CLARIFICATIONS No. 3

CONSTRUCTION OF THE NEW ELEMENTARY SCHOOL “CITY KVART” PODGORICA, MONTENEGRO

ICB No: 01-908/26-788/1 published on 11 March 2026

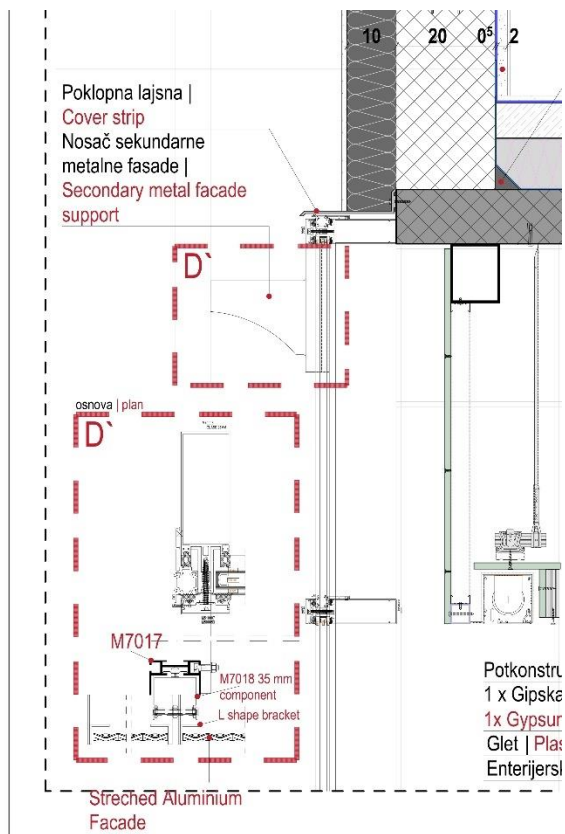
2.1. Architecture-Object; Facade works; 4 Facade of stretched aluminium. The project does not provide any details regarding the facade mesh. It is not shown in the cross-sections through the object or in the given details. It is not known what the stretched aluminium panels should look like, what dimensions the openings in the mesh should be. The fixing details for the structural facade are also not known. The above affects the price of the position. Please provide information

Installation and mounting of expanded aluminium mesh façade as part of the pavilion's double-skin façade system. Panel dimensions (width/height): 1500/3000 mm. Spacing between elements: 25.00 mm. Panels must be designed for installation and removal. Sheet thickness: 2 mm. Mesh opening DL x DC: 200 mm x 80 mm. Sharp panel edges must be treated and covered with trim profiles for injury protection. Panel width tolerance: ± 5 mm; panel length tolerance: $-0 / +25$ mm.

Please find below the detail of the expanded aluminium mesh:
